Cooperative Hydrology Study (COHYST) Independent Peer Review Findings Final Report

October 15, 2005

The purpose of the Independent Peer Review was to evaluate the credibility of the model reports, the underlying model datasets, and supporting data and information by providing answers to the following questions:

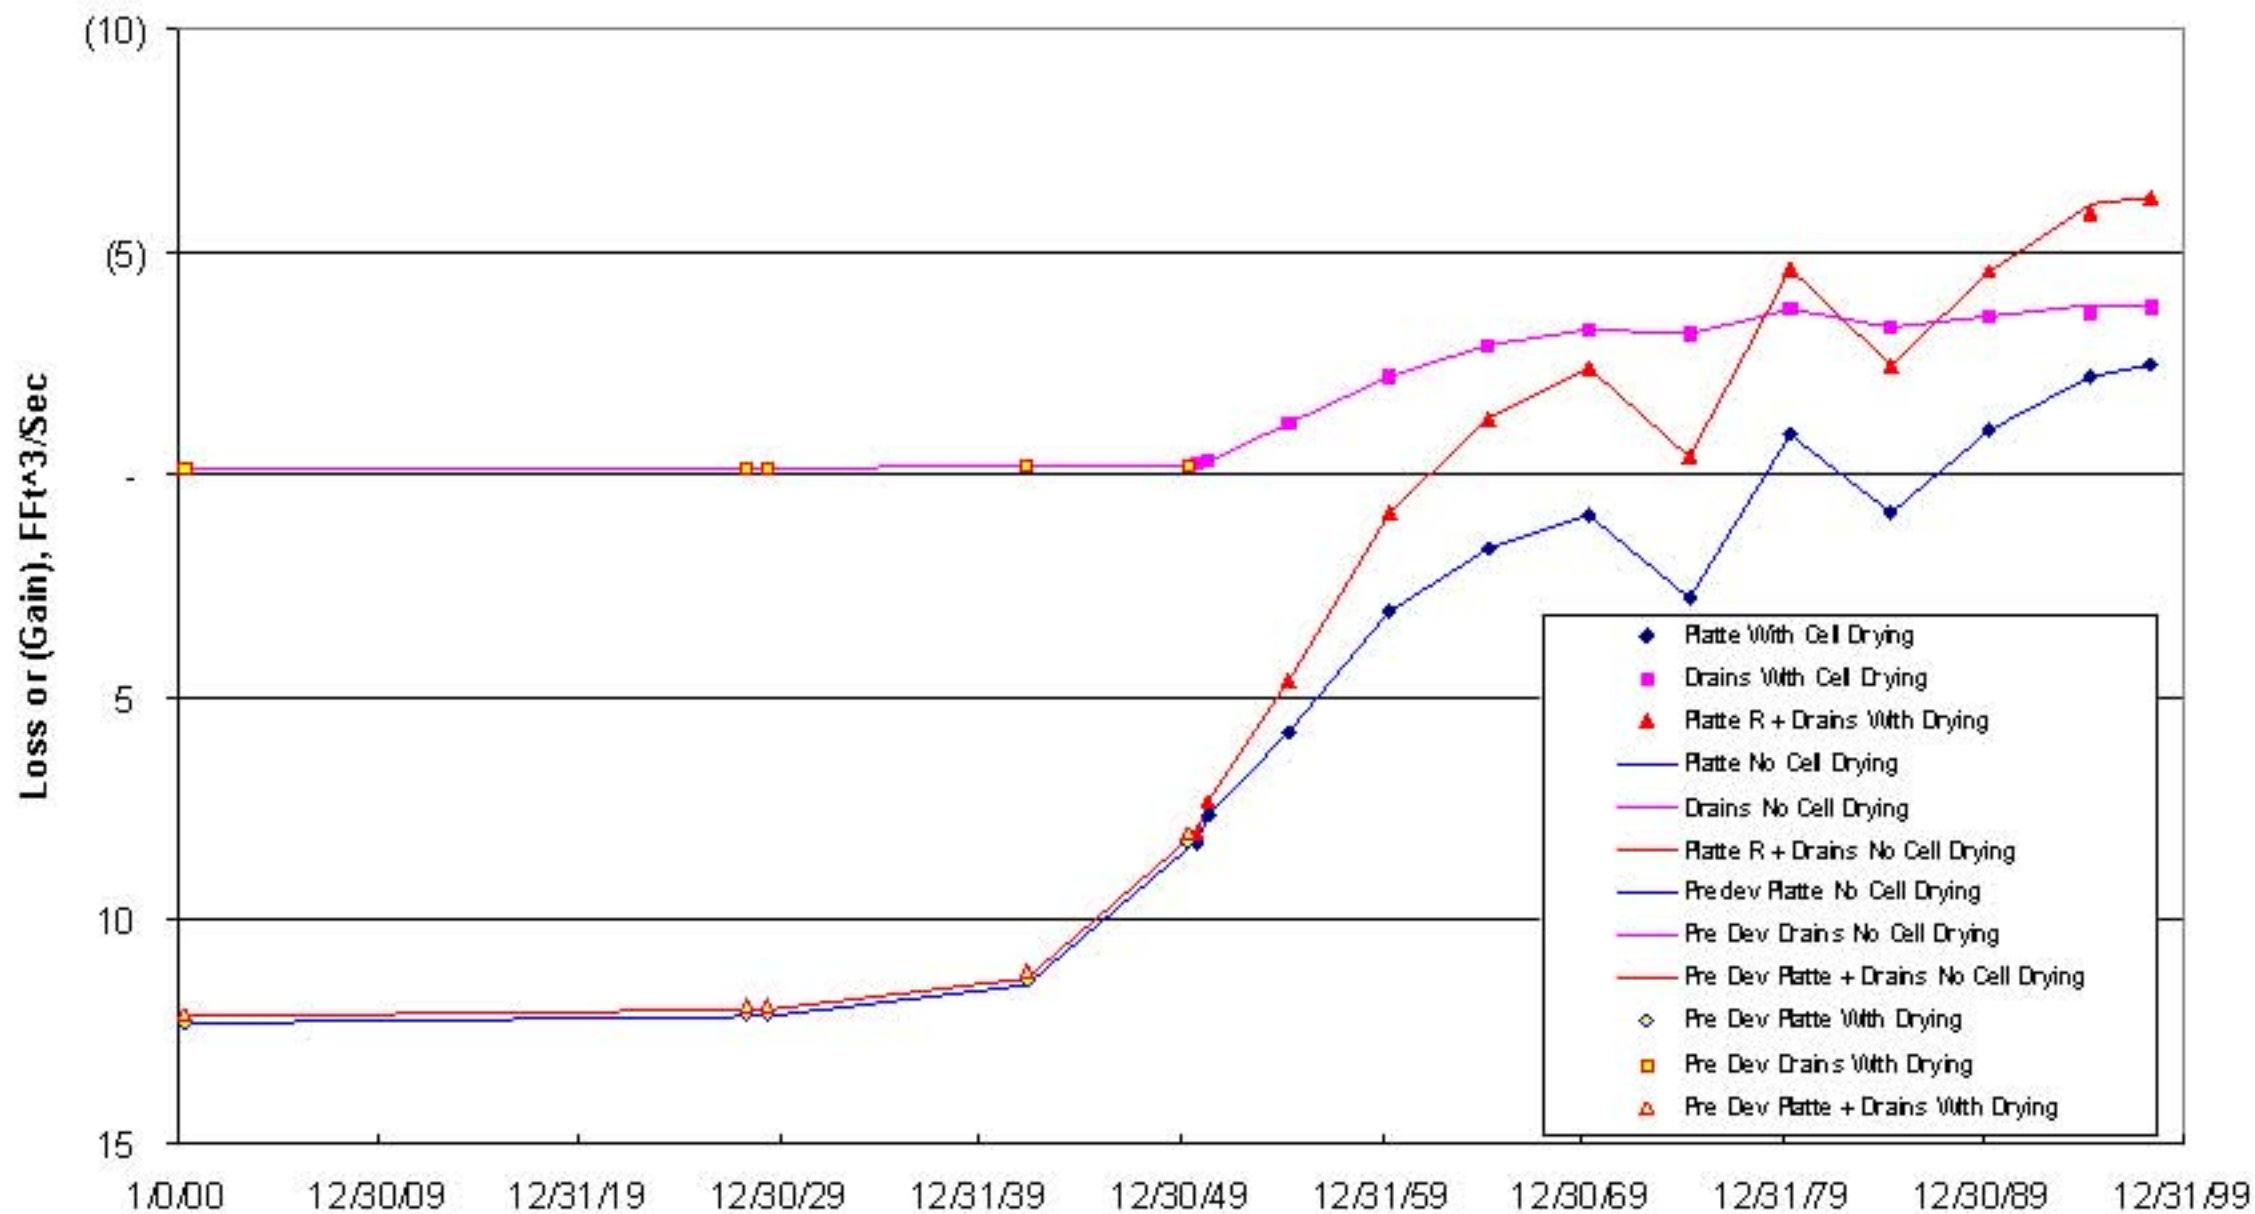
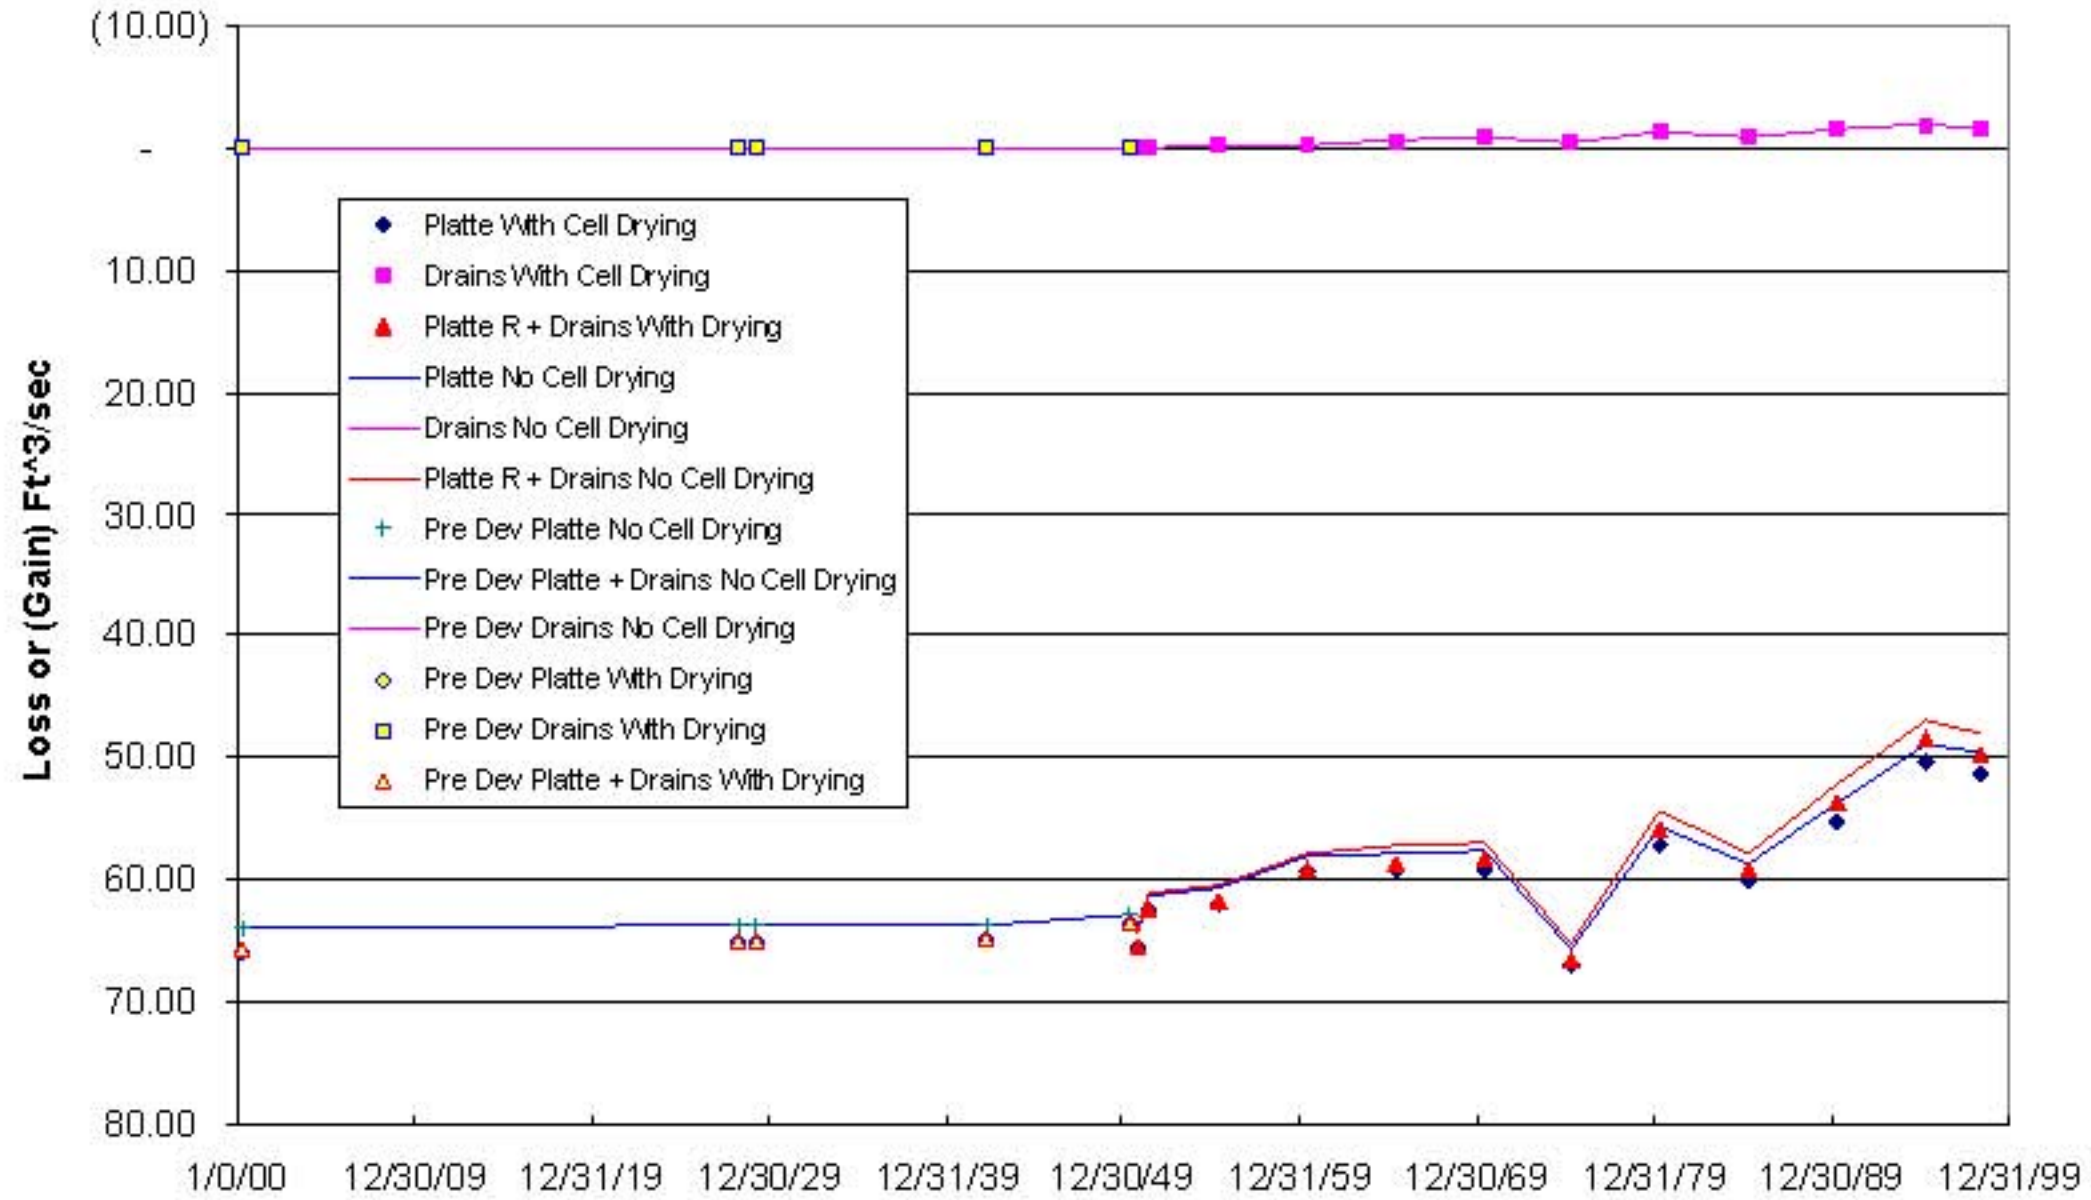
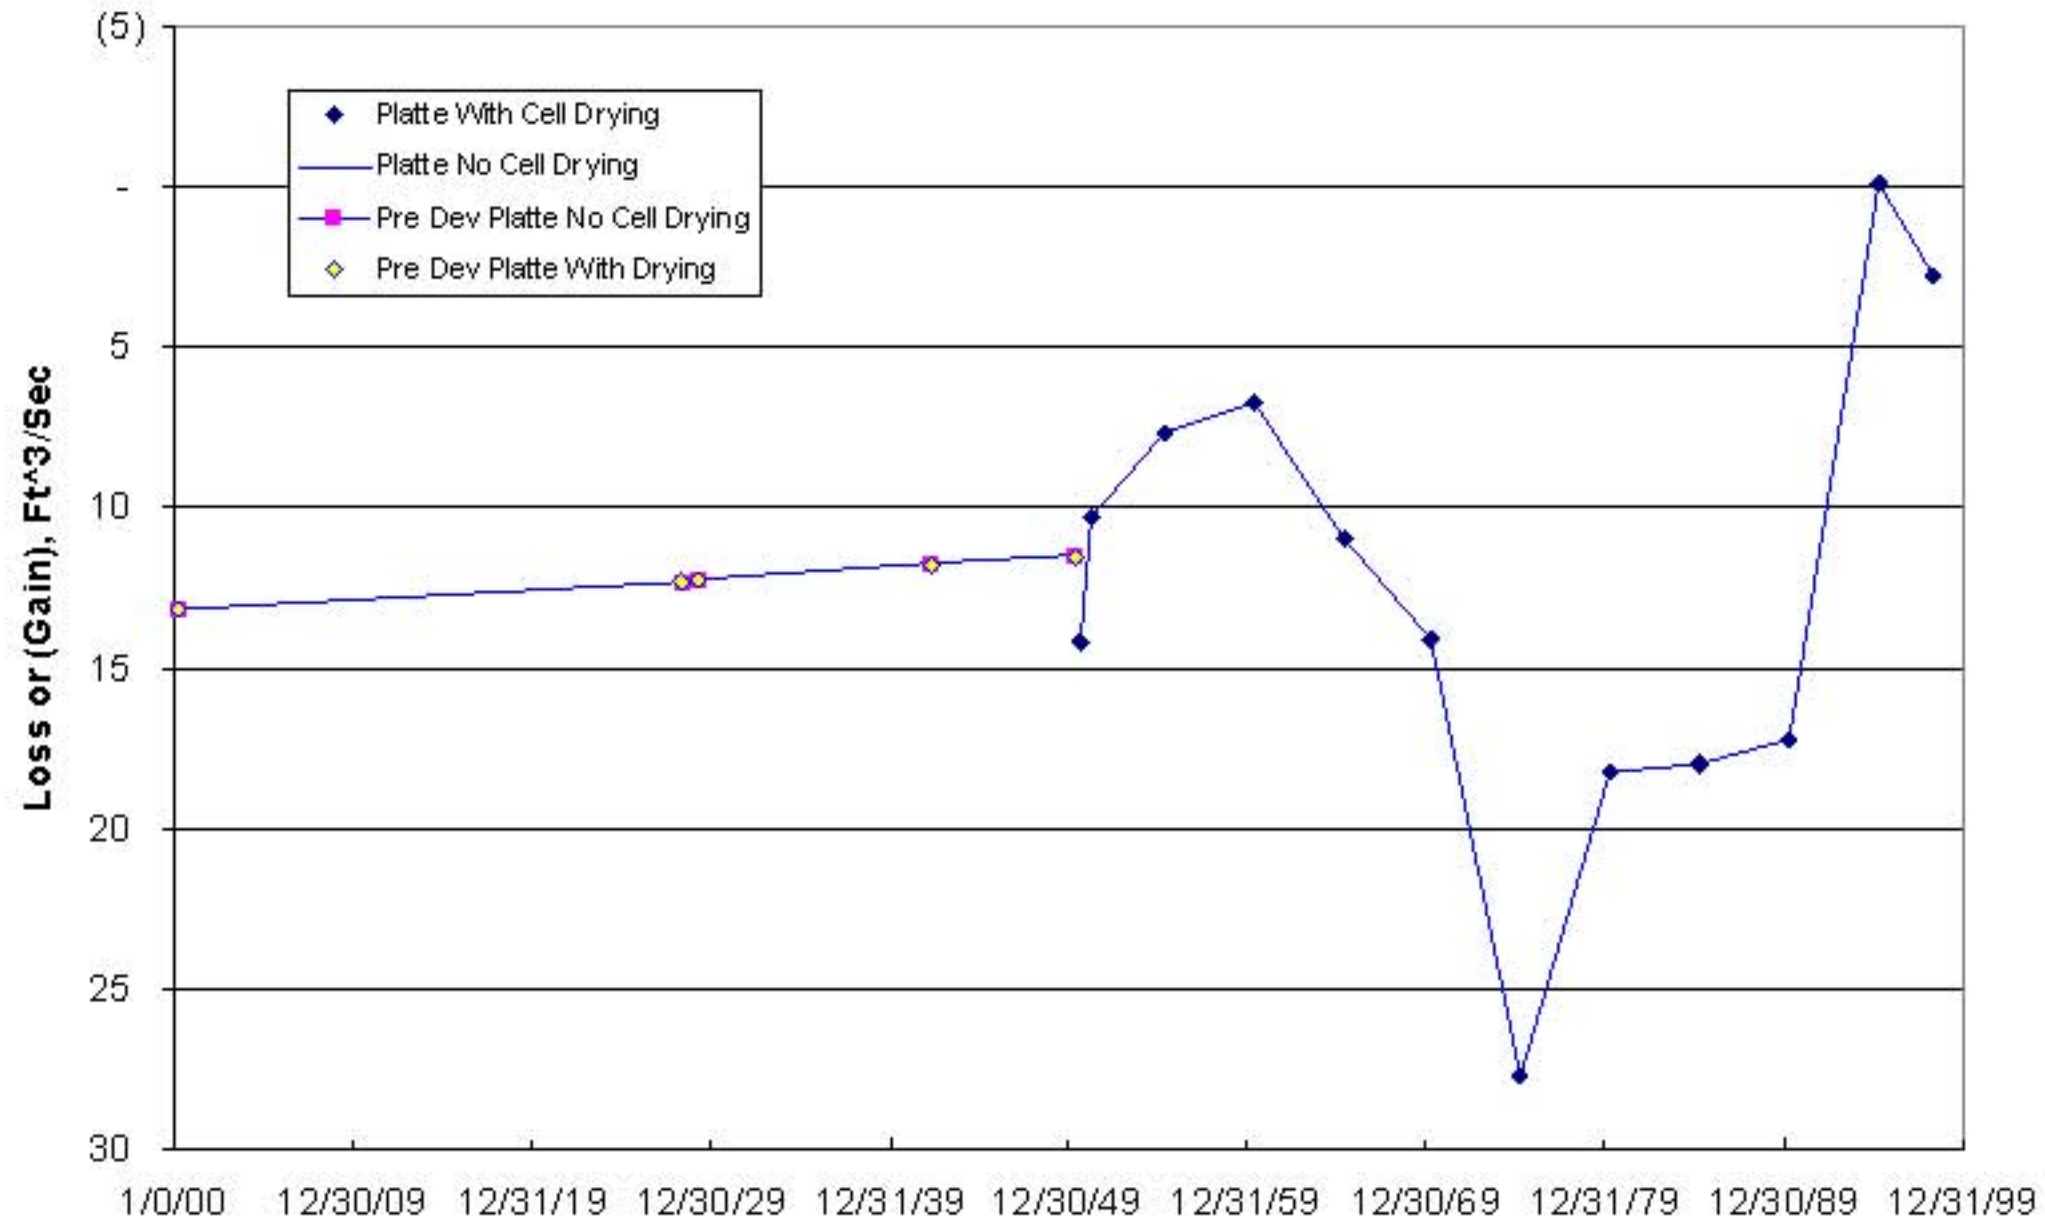
Comment 6.1.2.6 (p. 35) says that simulated ground-water discharge to streams from the end of the pre-ground water development simulation does not match simulated ground water discharge to streams at the beginning of the ground water development period simulation, and refers to figures 22-27 which includes plots of simulated ground-water

discharge to streams for several reaches of the Platte River in the Eastern Model Unit. Using GMS 3.1, the simulated ground-water discharge to these streams was evaluated for both models at simulated times that were 1 hour apart. The values the Platte River for Cozad to Overton, Overton to Odessa, Odessa to Grand Island, and Grand Island to Duncan for both models were found to be within 0.12 ft³/s, well within the limit of calculation error. Further, only the values for the Odessa to Grand Island reach were different by more than 0.05 ft³/s. Figure 25 shows a discrepancy between the two simulations (Grand Island to Duncan reach) that is clearly much larger than any of the values found during this check, and may indicate that either an error was made by the reviewers or the simulated discharge data was not retrieved in the same way. As additional background, it has been noted during the COHYST project that GMS 5.1 does not always reliably report ground-water discharge to streams, so perhaps that could explain the difference between COHYST findings and the peer review findings. In addition, the values on figure 25 seem to be around 12 to 14 ft³/s (loss), while the values retrieved using GMS 3.1 were about 20 ft³/s (loss). A brief check showed that while scale issues on figures 22-24 made a strict comparison difficult, it appears that the discharge for each of those three figures was different from what was retrieved using GMS 3.1 (see table).
